# UNITED STATES PATENT AND TRADEMARK OFFICE

<b>Office Action Summary</b>	<b>Application No.</b> 10/031,218	<b>Applicant(s)</b> FILSHIE ET AL.	
	<b>Examiner</b> Darwin P. Erez	<b>Art Unit</b> 3773

## **DETAILED ACTION**

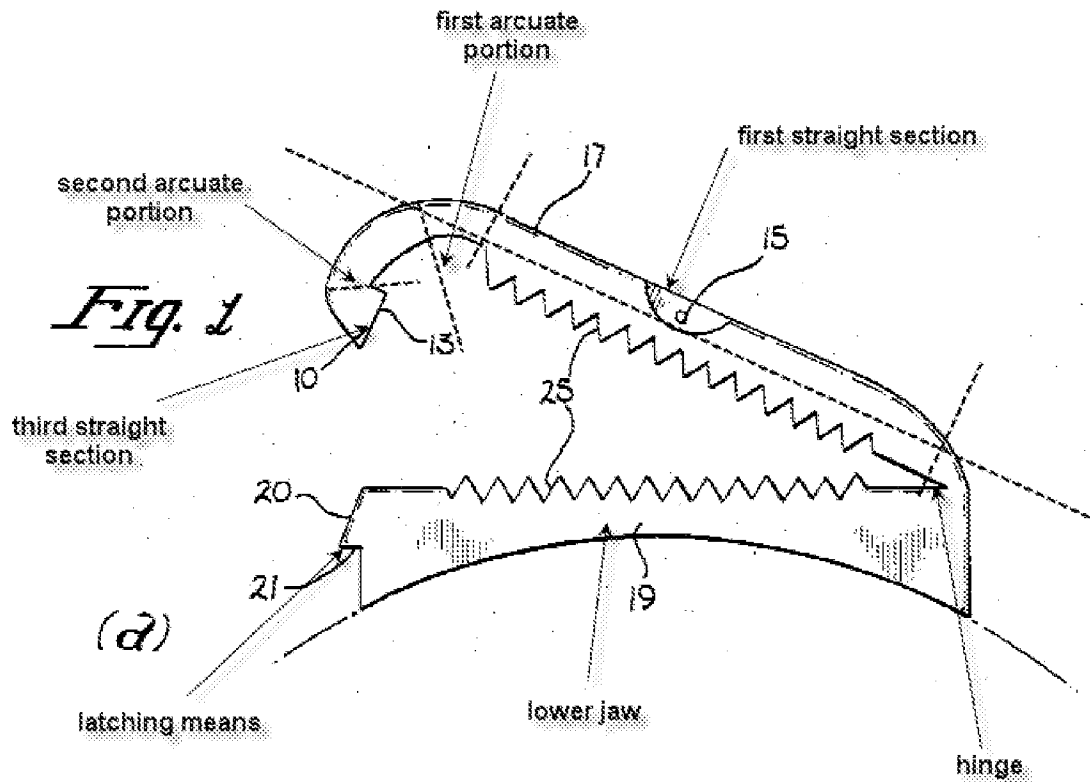
As seen in the attached figure below, Lingua discloses a surgical clip comprising:

- an elongate upper jaw and an elongate lower jaw attached together at a first hinge end;
- the lower jaw being provided with latching means at an opposite end to the hinge;
- the upper jaw comprising a complex shape comprising:
  - a first straight section adjacent to the hinge,
  - a second arcuate shaped section adjoining the straight section and in which the second arcuate shaped section comprises:
    - a first arcuate shaped portion adjacent to said straight section, and
    - a second arcuate shaped portion adjacent to said first arcuate shaped portion at an opposite end of said first arcuate shaped portion to said straight section,

- wherein the first and second arcuate shaped portions each have an inner and outer surfaces,
- wherein said first arcuate shaped portion having a first radius of curvature on at least its inner contact surface that is substantially greater than the radius of curvature of said second arcuate shaped portion which has a second radius of curvature,
- wherein a center of the radius of curvature for both the first and second arcuate shaped portions is located on the same side of the upper jaw,
- wherein there is an absence of a straight portion between the first and second arcuate shaped portions.

As seen in the attached figure above, Lingua discloses a surgical clip comprising:

- wherein a center of the radius of curvature for both the first and second arcuate shaped portions is located on the same side of the upper jaw,
- wherein the first and second arcuate shaped portions are contiguous and have the same width with the straight portion (as seen in Fig. 2); wherein the bottom edge of the device shown in Fig. 2 is viewed as "an inner surface" and the top edge of the device is viewed as the "outer surface", both being flat surfaces (note that the inner and outer surfaces of the straight section has not been clearly defined relative to any other structure),

Lingua discloses all the limitations of the claims except for the clip having a silicone rubber lining on both sides of the jaws; with the first radius of curvature is of the order of three times that of the second radius of curvature; and to the jaws being connected together via a hinge pin.

16. Applicant's arguments regarding the rejections under the Lingua reference have been fully considered but they are not persuasive. The applicant argued that Lingua fails to teach a first and second arcuate shaped portions, as amended. However, the examiner had updated the marked up drawing above to clearly show which portions are viewed as the first and second arcuate shaped portions. As shown above, Lingua discloses a first arcuate shaped portion adjacent the straight portion, and a second arcuate shaped portion adjacent the first arcuate shaped portion. Both the first and second arcuate shaped portions have inner surfaces, wherein the inner surface of the first arcuate shaped portion has a larger radius of curvature than that of the second arcuate shaped portion. As for the argument that the combination of Lingua/Casey fails to teach applying a force to only the straight section, the examiner is again noting that it would be obvious to apply force any where along the length of the clip as any position would still allow the clip to close. The applicant's arguments shown in page 10 pertains only to the applicant's embodiment but not to the combination of Lingua and Casey because Casey does not teach a tubular member. Note that 10 merely recites a clip closure member and not a tubular member.
